REMARKS

Claim Amendments

Example of a trisoid.

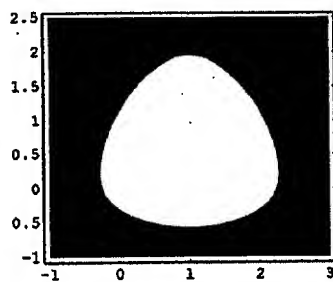
New claims 86-88 are directed to a filter unit having trisoid-shaped openings. This feature is supported in the specification and drawings of the application as originally filed (See, e.g., FIG. 14 and published application, paragraph [0059]). Referring to the Office Action dated May 23, 2002, page 4 (See Exhibit A), Applicant agrees with the Examiner's reading of the "Beyond the Ellipse" (See Exhibit B) definition for a trisoid to mean a curve that results when the total distance from three points is kept constant. Applicant hereby withdraws any definition of trisoid meaning a triangle with radially rounded edges, so that there are not pointed edges in the openings, to the extent that this second definition is inconsistent with the definition from "Beyond the Ellipse" provided in the previous sentence.

10. Claims 46-49 and 51-58 are rejected under 35 U.S.C. 112, second paragraph, as being indefinite for failing to particularly point out and distinctly claim the subject matter which applicant regards as the invention. It is unclear what is intended by the term "trisoid". In the most recent communications, Paper Nos. 17 and 20, applicant apparently withdraws the previous definition of "trisoid", which applicant set advanced in Paper No. 15, and now states "Applicant agrees with the Examiner's reading of the 'Beyond the Ellipse' definition for a trisoid being a curve that results when the total distance from three points is kept constant". However, applicant then sets forth yet another definition stating "The desired shape, for the openings that are called 'trisoids' in the specification, is a triangle with radially rounded edges, so that there are not pointed edges in the openings". This contradicts the 'Beyond the Ellipse' definition, for
